orbit_demo review notes: issues, trade-offs, questions, discrepancy register

Package section 09_review_notes of orbit_demo_design_review, written 2026-10-06. Links are relative to this file. Paths in backticks without a link (reports/..., build/..., site/..., viz/..., docs/research/..., ORFS image paths) are repository, build or tool-image paths in /home/user/chip that are not copied into the package. "repo" = /home/user/chip.

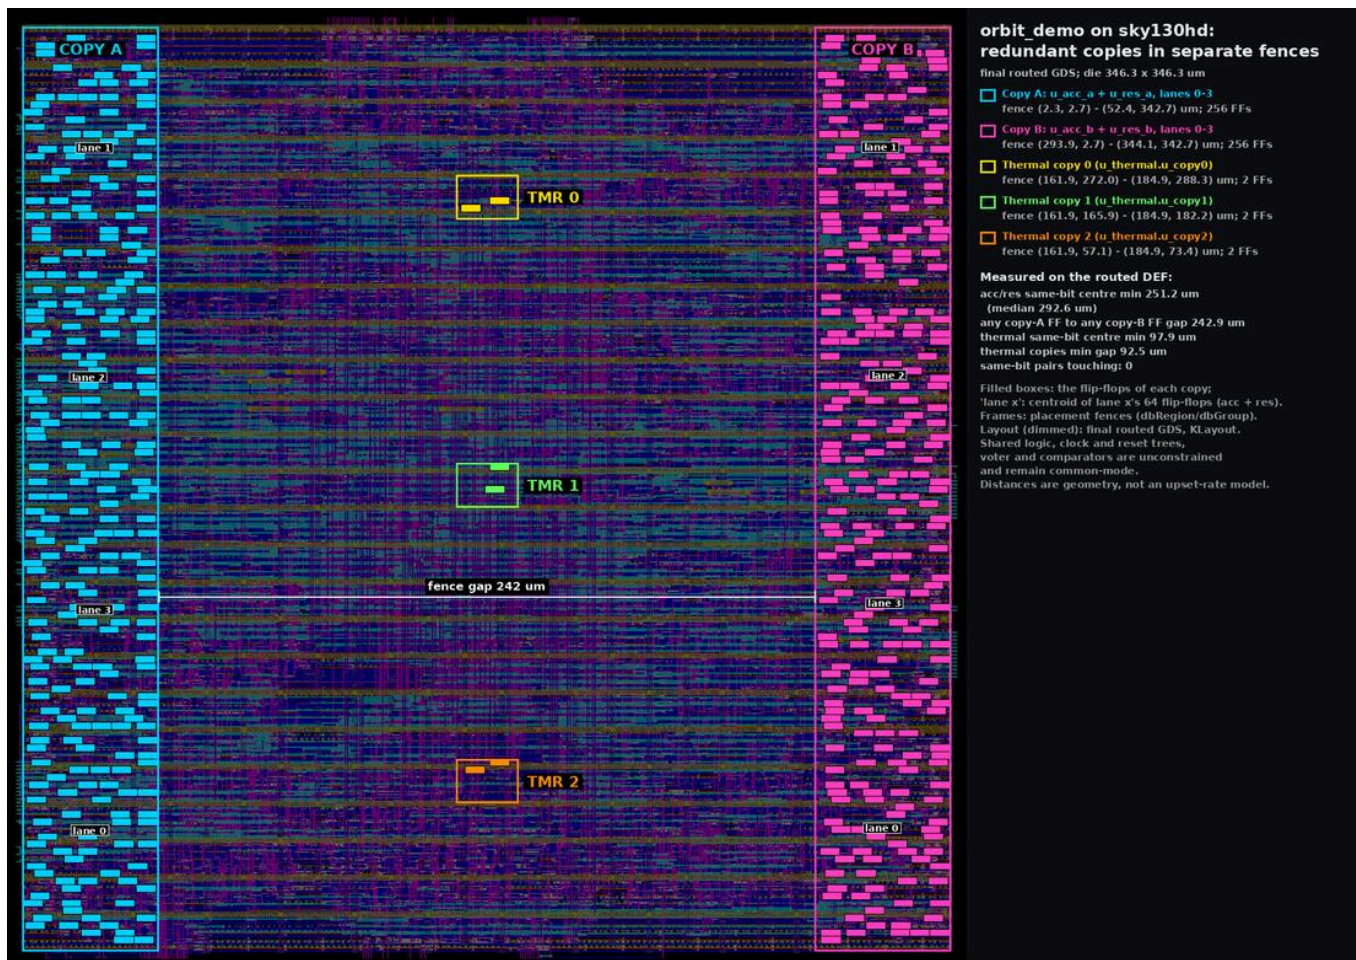
K-02	High	Single points of failure. One instance, feeding both copies, of: the 8x8 multiplier and prod32 per lane (orbit_mac_lane.v:24-26); the A/B comparators (orbit_mac_lane.v:59) and the mismatch OR-tree mismatch = \ lane_mismatch (orbit_demo.v:55); the lane control in_fire → mac_en, clear_fault → clr, in_first, in_last, acc_en/res_en and the clr d-mux selects (orbit_demo.v:81-84; orbit_mac_lane.v:36-57); the thermal voter (orbit_thermal_tmr.v:40) and the one nxt cone that writes all three copies (:44-68); the unprotected u_thermal.phase (:72-78), fault_q and out_valid_q (orbit_demo.v:57-58, 107-122); the clock (one CTS tree, 521 sinks); rst_n (synchronous, no synchronizer); the sensor and handshake inputs. In the reviewed netlist, shared drivers also cross copies: clknet_leaf_22_clk clocks u_thermal.u_copy0/q[1] and u_thermal.u_copy1/q[1]; place1872 (buf_4, net net1870) drives reset gates of u_thermal.u_copy1, u_thermal.u_copy2, g_lane[2].u_lane.u_acc_a, g_lane[2].u_lane.u_res_a and g_lane[3].u_lane.u_acc_a. SPEC section 8 lists only part of this (D-01).	RTL in source/rtl/SPEC.md 151-162; 4_1_cts.log ; netlist 6_final.v.gz ; summary.md 194-195	RTL at 26566f0; netlist = sep_6_final.v (sha256 68093c41...), parsed 2026-10-06	REPRODUCED 2026-10-06

ID	Sev.	Description	Files	Evidence	Suggested resolution
D-13	Low	Fence gaps rounded inconsistently: regions.tcl "about 240 um" (copies) and "about 100 um" (thermal); summary.md "242 um"; PNG label "fence gap 242 um". Measured fence edge gaps 241.50 um (A/B), 89.76 and 92.48 um (thermal); 242.94 um is the FF-to-FF gap.	src/pd/sky130_hd_sep/regions.tcl; published_reports/summary.md, .png	regions.tcl 49-50; summary.md 151, 153; separation.md 31, 53-62	Quote measured values with their definition.
D-14	Low	regions.tcl/config.mk say the detailed placer keeps non-members from lying fully inside a fence; the routed DEF has 2 antenna diodes fully inside (inserted after placement). summary.md documents it.	regions.tcl; config.mk	regions.tcl 14-16; config.mk 48-53; separation.md 39; summary.md 121	Add "except antenna-repair diodes".
D-15	Low	requirements-tools.txt: "model/ and the scripts use the standard library only"; scripts/pdsep_render.py imports klayout.db/klayout.lay and Pillow (mk/pdsep.mk pip-installs klayout==0.30.12 pillow), pd/render_layout.py imports pya, and the cocotb bench needs cocotb, which is not pinned.	src/requirements-tools.txt; src/scripts/pdsep_render.py; src/pd/render_layout.py; src/tb/cocotb/run_random.py	requirements-tools.txt 15; pdsep_render.py 17-19; render_layout.py 27; run_random.py 24; pdsep.mk 83	List and pin the Python dependencies.
